Access Compliance Report

Public Rights-of-Way

(Curb Ramps)

Intersection ID: 7065	Main Street: EBARA_LN	Cross Street: KINGVILLE_DR	Location: SE
ADA ID: 5FA950D3AB4E	Ramp Type: Directional1	Initial Pass/Fail: Pass	Overall Compliance: No
Codes/Mitigation Info/Possible Solution			Severity Score: 10
			Field Measurements/Component Compliance

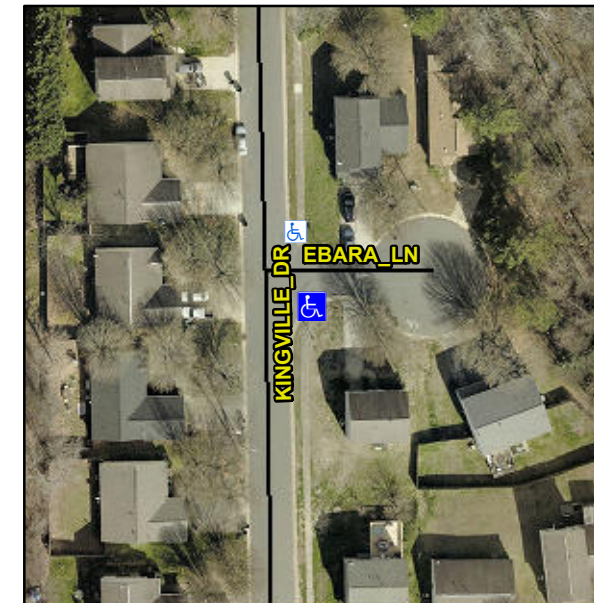
CURB GAP 1.0

**Not Found, R304.2.1, R304.2.2-Perp,
R304.3.2-Para, R304.5.3, R305.1.4,
R302.7.2**

Compliance	Description	Data	Compliance	Description	Data
N/A	Ramp Length (in)	49.5	Yes	Grade Break?	Yes
Yes	Ramp Width (in)	49.0	No	Grade Break Slope (%)	6.1
Yes	Ramp Slope (%)	6.1	Yes	Grade Break XSlope (%)	0.2
Yes	Ramp XSlope (%)	2.0			
N/A	Flare Type LT	N/A	N/A	Flare Type RT	N/A
N/A	Flare Slope LT (%)	N/A	N/A	Flare Slope RT (%)	N/A
N/A	Flare Traversable LT?	N/A	N/A	Flare Traversable RT?	N/A
No	Landing Length (in)	30.0	Yes	DWS Provided?	Yes
Yes	Landing Width (in)	49.0	Yes	DWS Contrast?	Yes
No	Landing Slope (%)	6.4	Yes	DWS Length (in)	25.5
No	Landing X Slope (%)	2.2	No	DWS Full Width?	No
N/A	Landing Curb? (Y/N)	N/A	Yes	DWS Offset LT (in)	20.0
N/A	Shared Landing?	No	Yes	DWS Offset RT (in)	1.5
Yes	Gutter Ponding?	No	Yes	Gutter Slope (%)	2.6
No	Gutter Lip Ht (in)	0.5	No	Gutter X Slope (%)	3.9
N/A	Painted X Walk1?	No		Road Slope (%)	1.3
	X Walk 1 Direction	To N		Road X Slope (%)	4.8
	X Walk 1 Width (in)	N/A		Clear Space?	Yes

**Remove & Replace Entire Ramp.
Remove & Replace Gutter.**
